ADDENDUM NO. 3

**APPOQUINIMINK SCHOOL DISTRICT
BRICK MILL EARLY CHILDHOOD CENTER
380 BRICK MILL ROAD
MIDDLETOWN, DE 19709**

Specifications and/or Drawings for
Brick Mill Early Childhood Center - #2001
Appoquinimink School District

July 16, 2020
.....

ADDITIONAL PARTITION TYPE D66
NOT TO SCALE

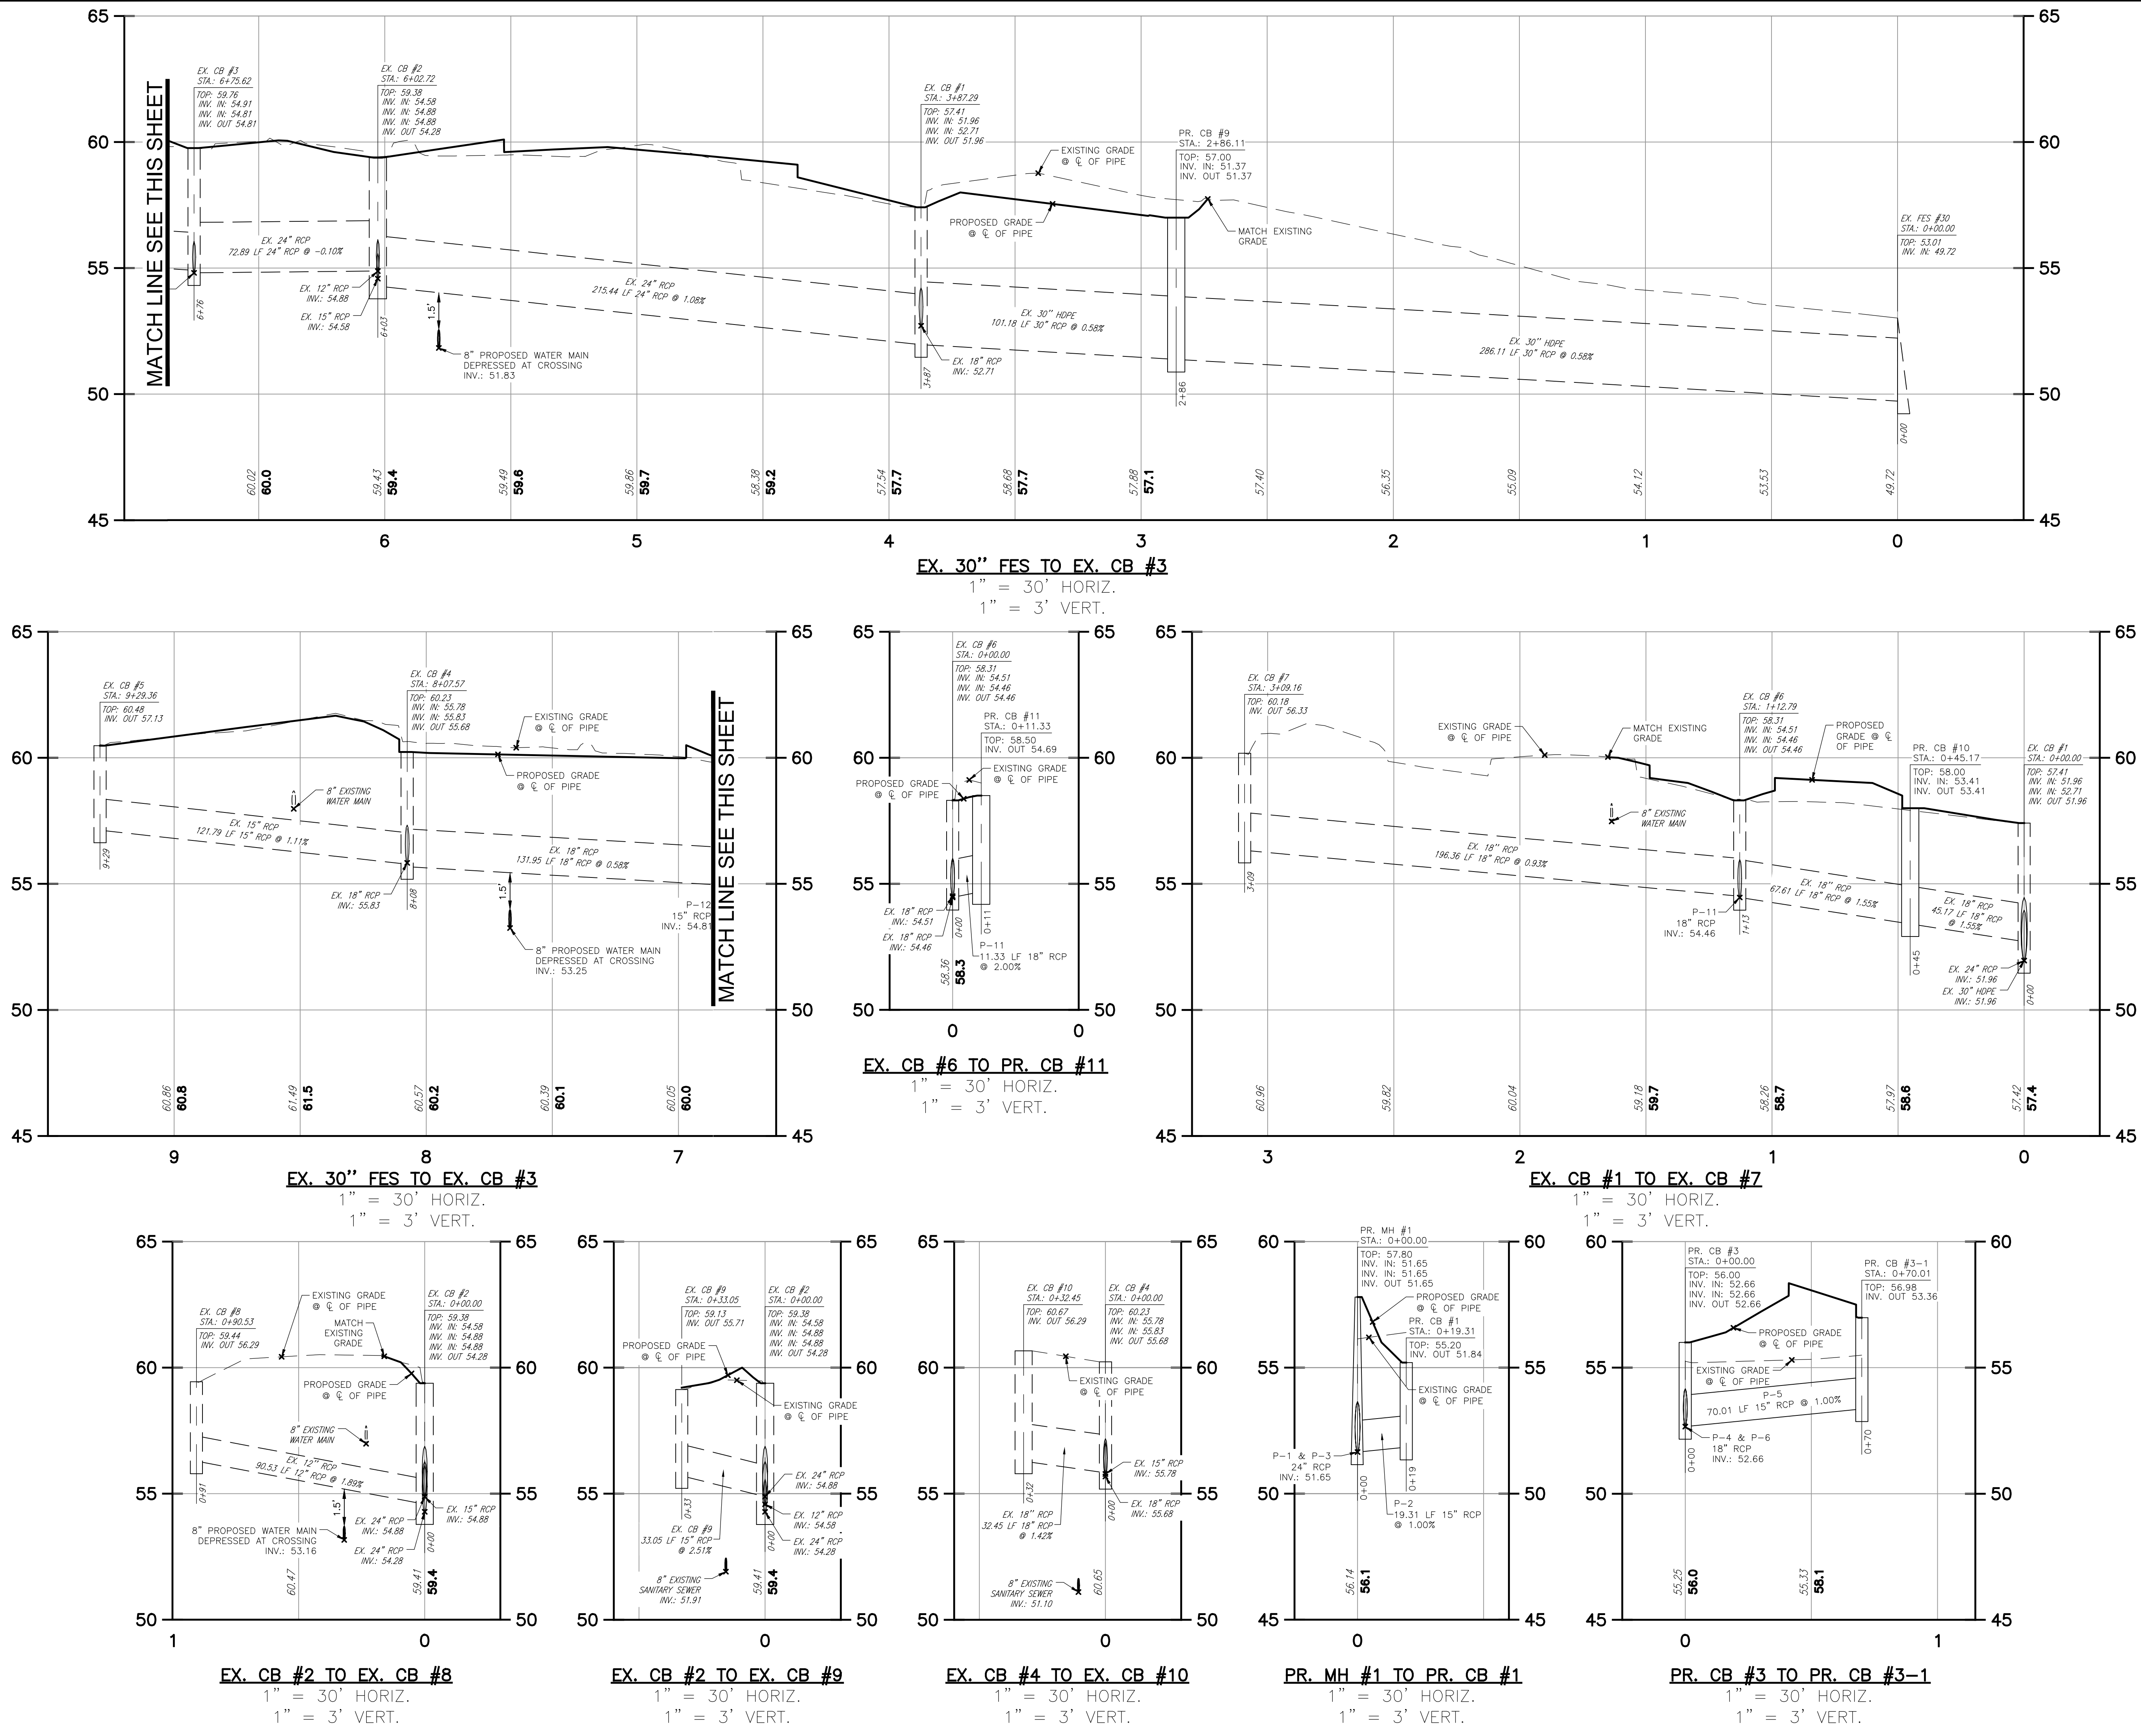
15	09	CD	Architectural	6/A6.2	Wall type D66 is not defined. Can you provide a detail?	7/16/2020	Detail will be provided as part of an addendum.
16	08	CD	Architectural	A8.2 / 088725	Jamb detail at frames receiving ballistic film do not match spec 088725. Which detail is to be provided?		
17	31	CD	Civil	N/A	Who will be providing the CCR for the project?	7/16/2020	Landmark will be providing the CCR
18	07	CD	Architectural		Please provide specification section for metal siding and metal flat-lock panels	7/16/2020	Specifications will be provided as part of an addendum.
19	27	CD	Electrical	E4.2	Clarify if communication conduit extends into the existing building from the existing Hand Hole		
20	26	CD	Telecomm	260740	Please provide enlarged, less blurry figures 1-8 documents.		
21	31	CD	Civil	CC-01	CC-01 9. Parking Calculations states that 18 bike racks are required (1 5-space rack and 13 single space racks). The locations for these bike racks are not indicated. Please provide bike rack locations.	7/16/2020	a proposed bike pad/rack location is provided on the plans as required
